NEBRASKA ARMY NATIONAL GUARD
Wahoo Readiness Center Addition

PROJECT NO. 31030344

A D D E N D U M N O . 1

FIRST FLOOR MECHANICAL PLANS

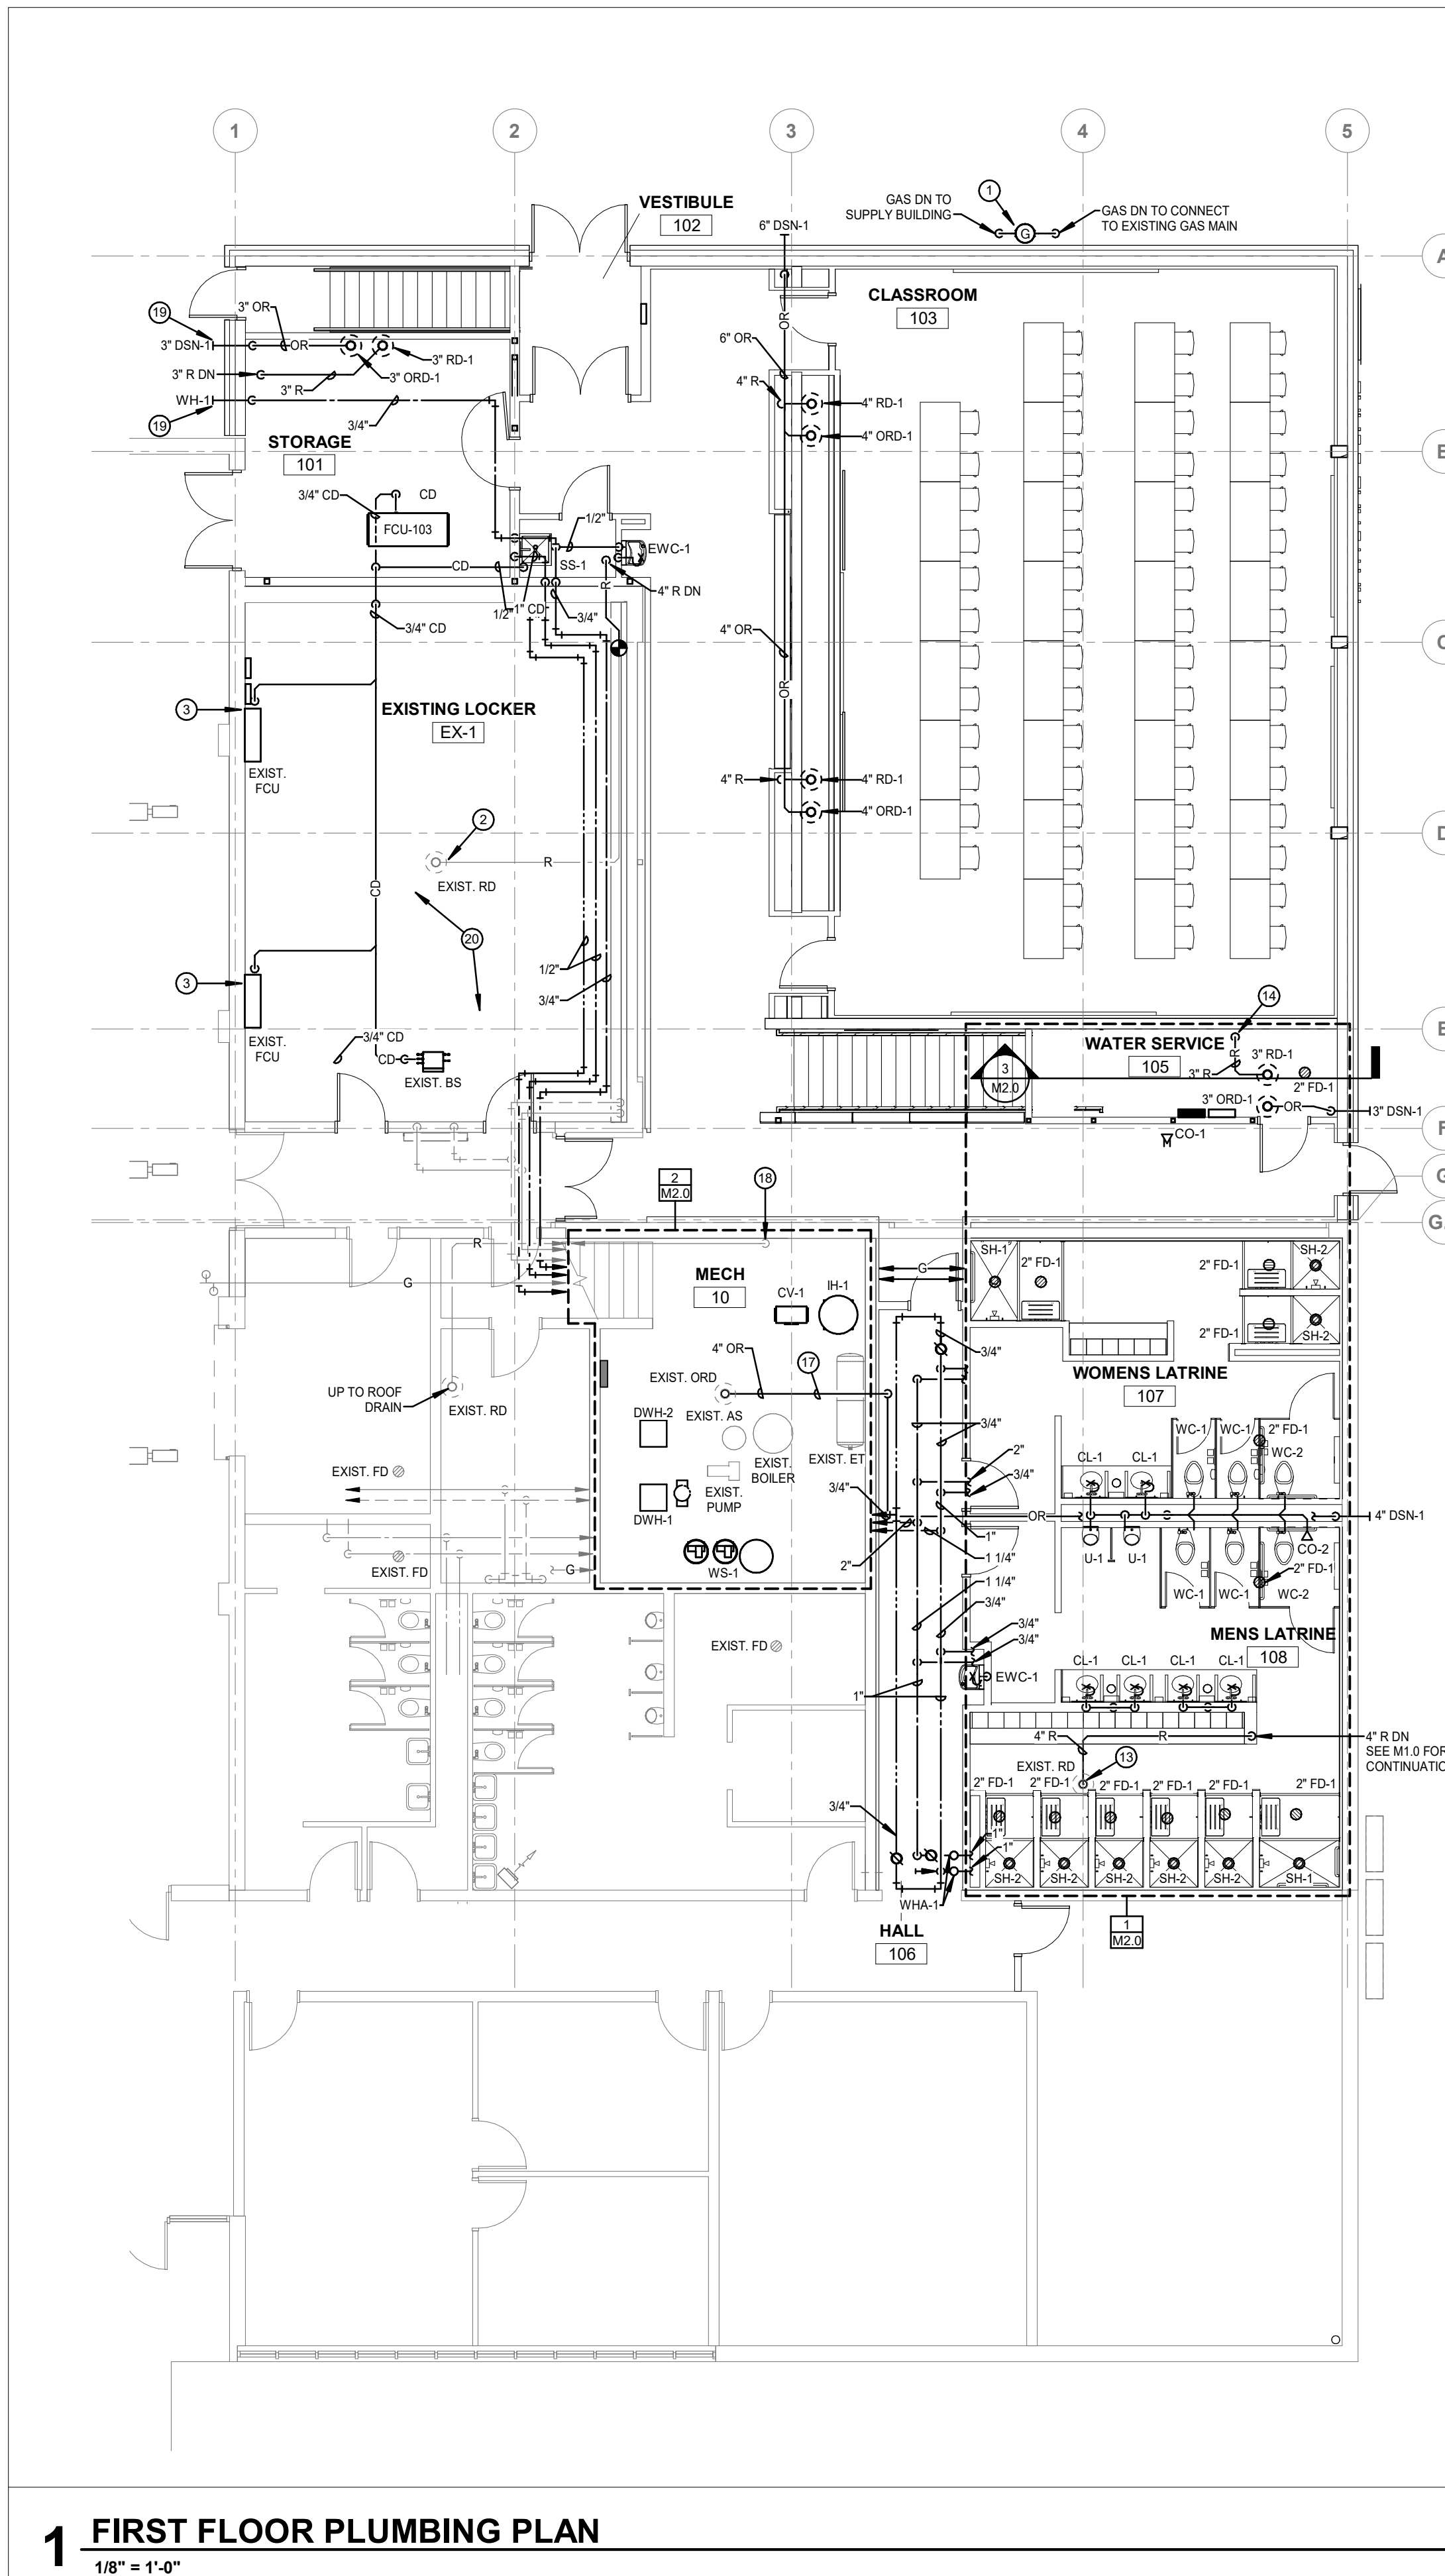
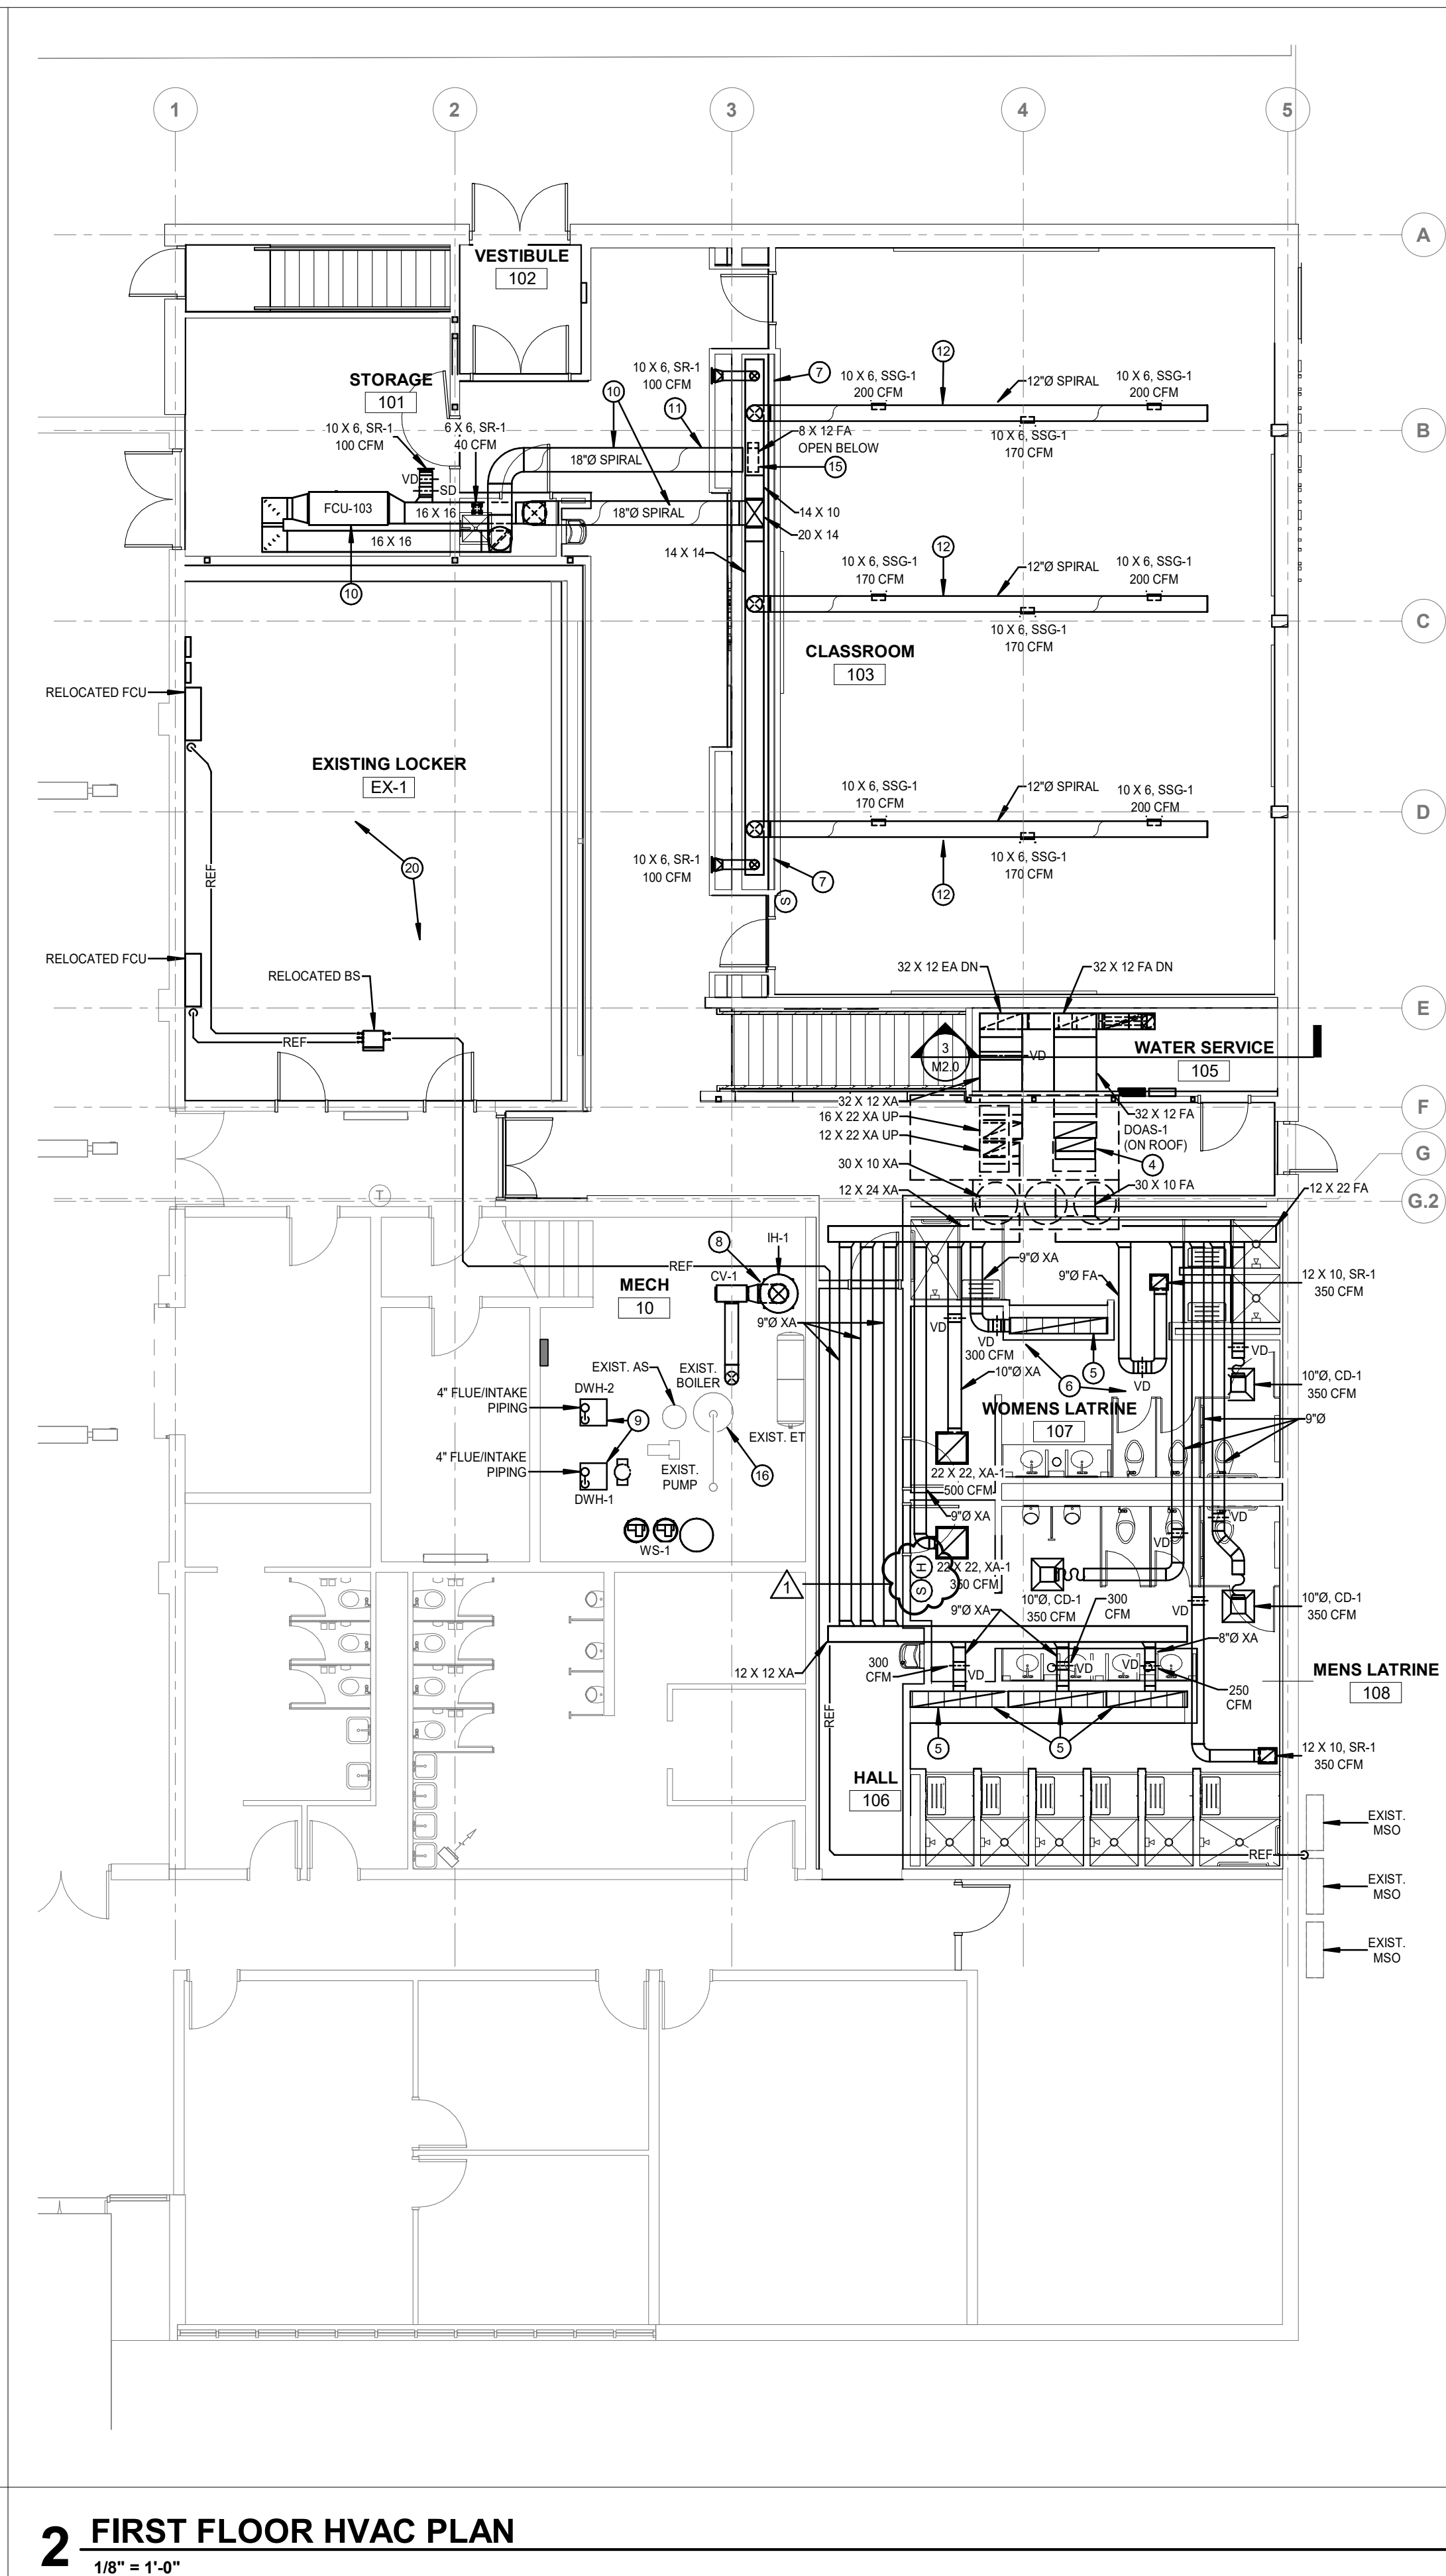
- 8. Sheet A9.1 FINISH PLANS
 - a. Detail 1: Alternate bid item number corrected.
- 9. Sheet M1.1 First Floor Mechanical Plans
 - a. Sheet note #20, changed ABI #2 to ABI #3.

- b. Added Humidity sensor in Men's Latrine 108
- 10. Sheet E2.1 First Floor Power Plan
 - a. Removed receptacle serving AV Rack due to AV System revisions.

1 FIRST FLOOR POWER PLAN
 1/8" = 1'-0"

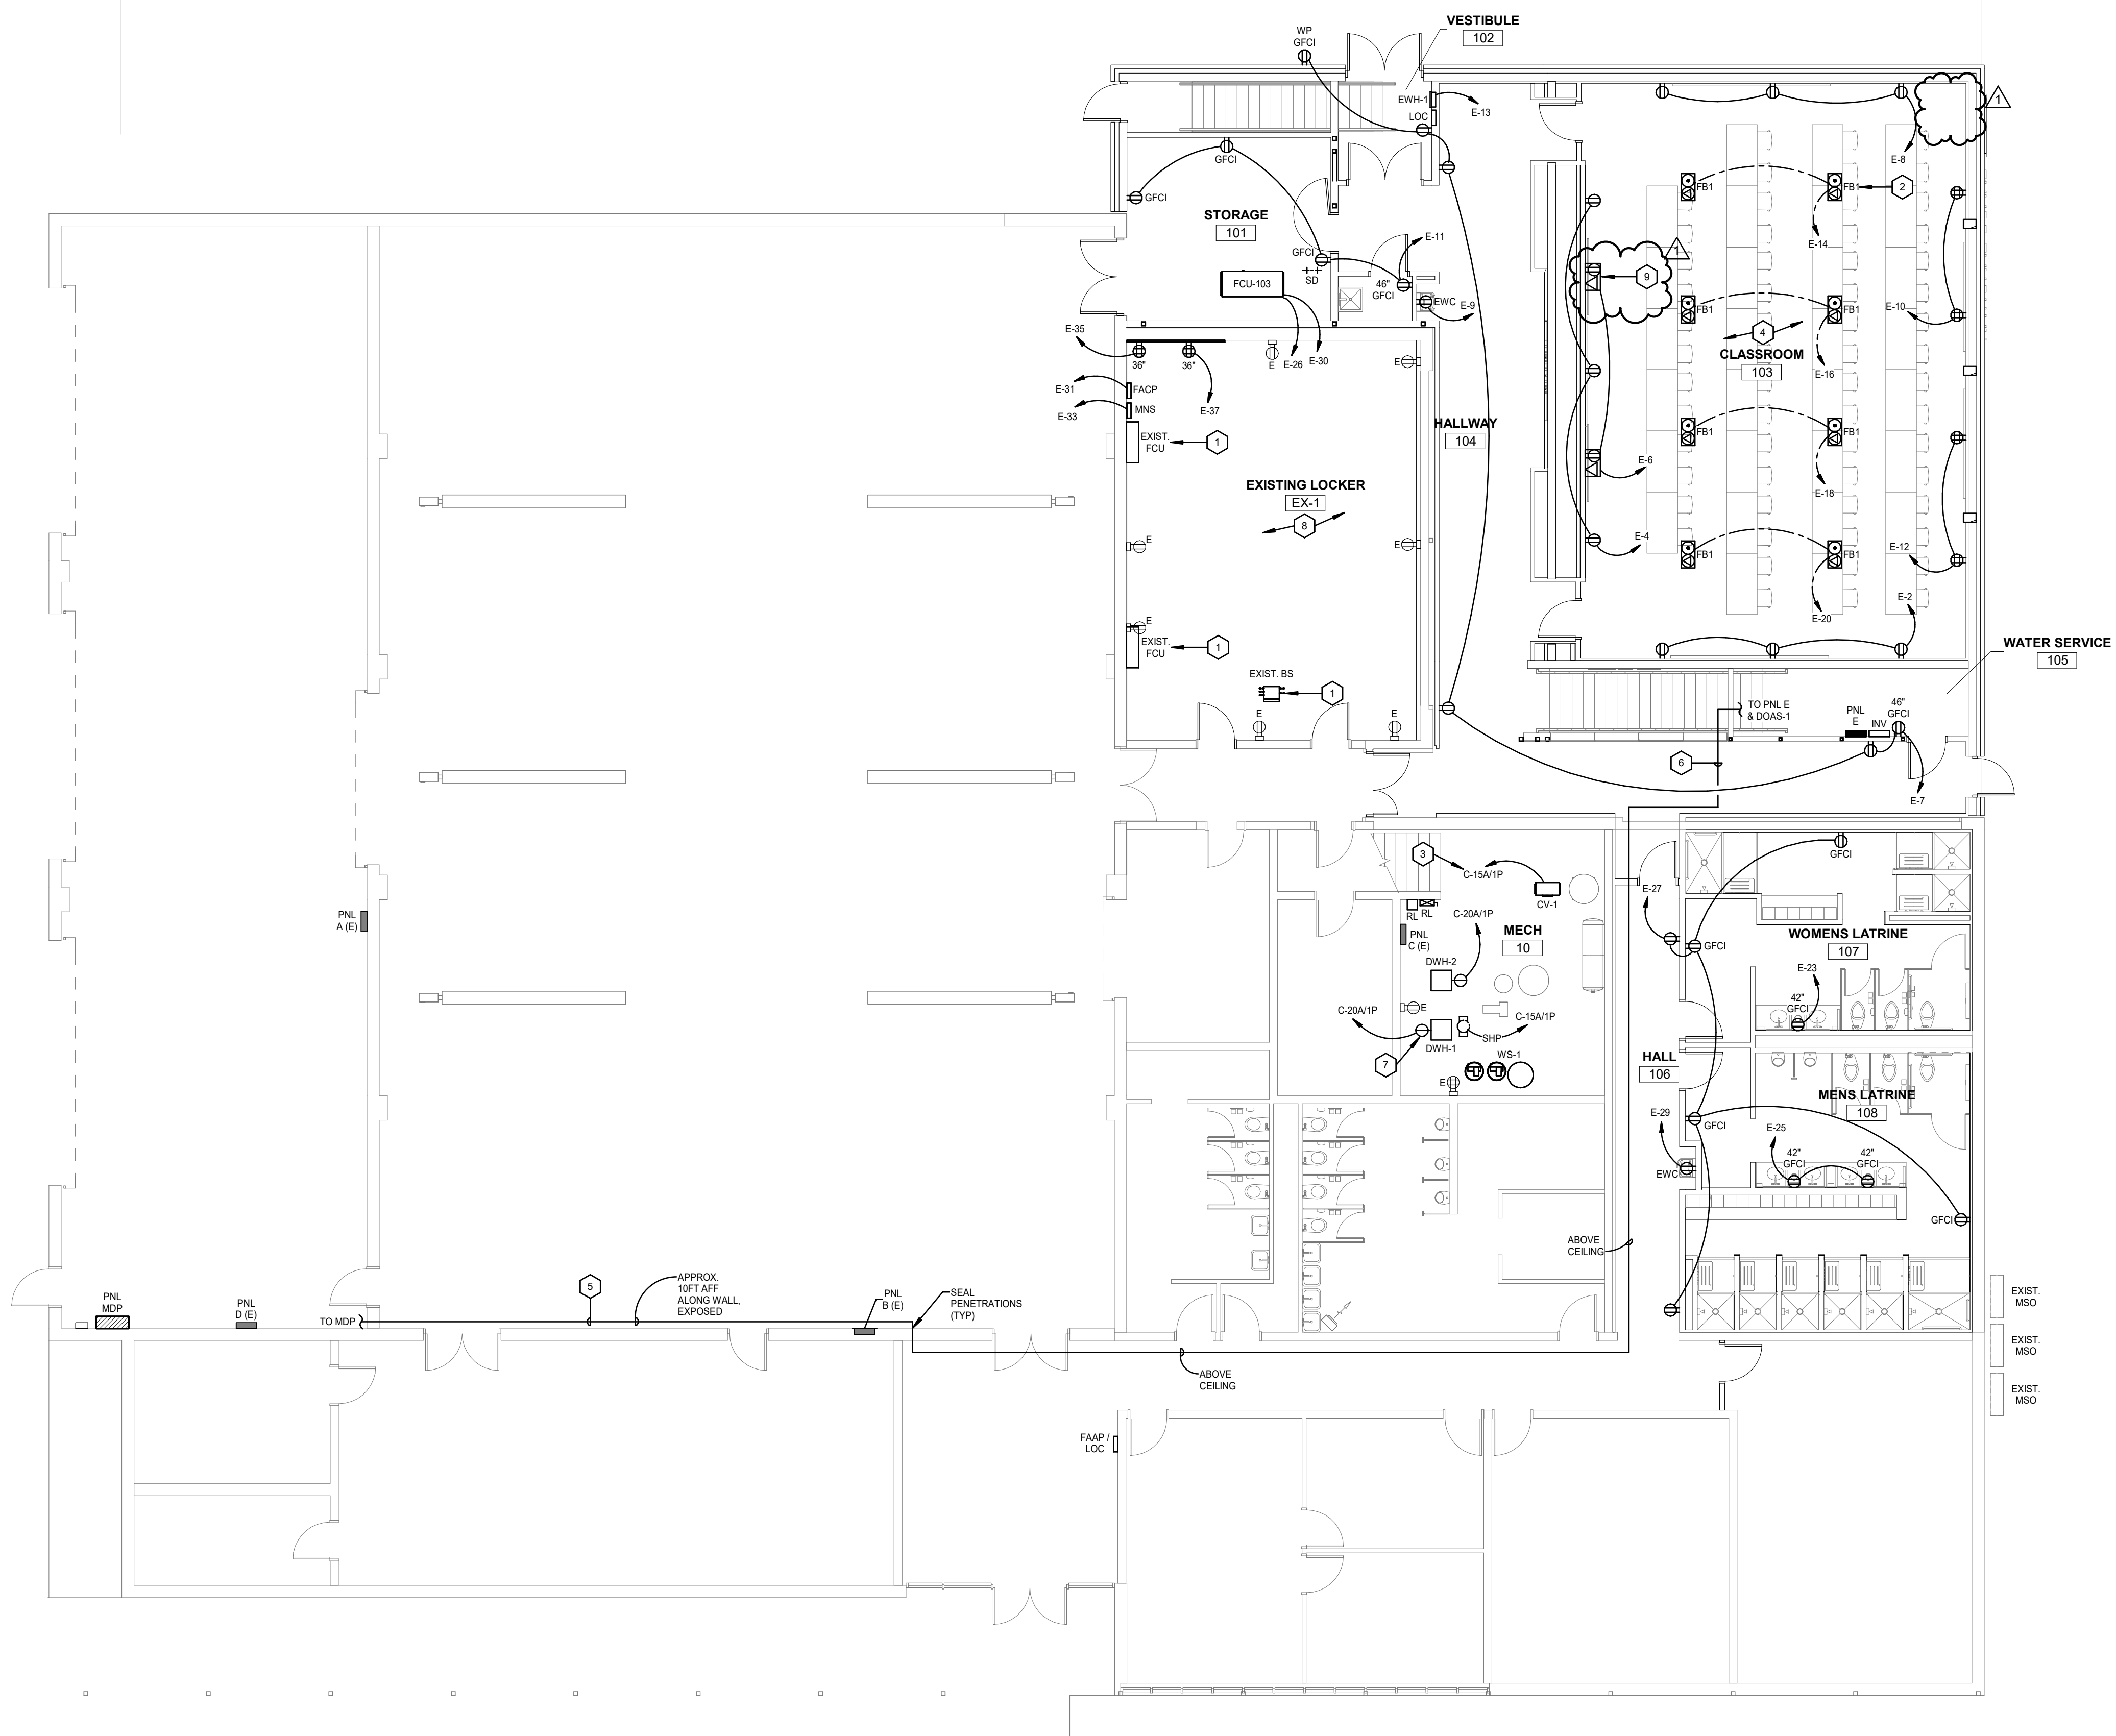
- b. Added Note 9 for wall box coordination.
- 11. Sheet E3.1 First Floor Technology Plan
 - a. Revised AV System requirements, including but not limited to: removing the AV Rack, revising cabling, revising AV equipment, and revising box requirements and locations.

- SEE SHEET E3.1 FOR WALL BOX REQUIREMENTS, (TYPICAL).
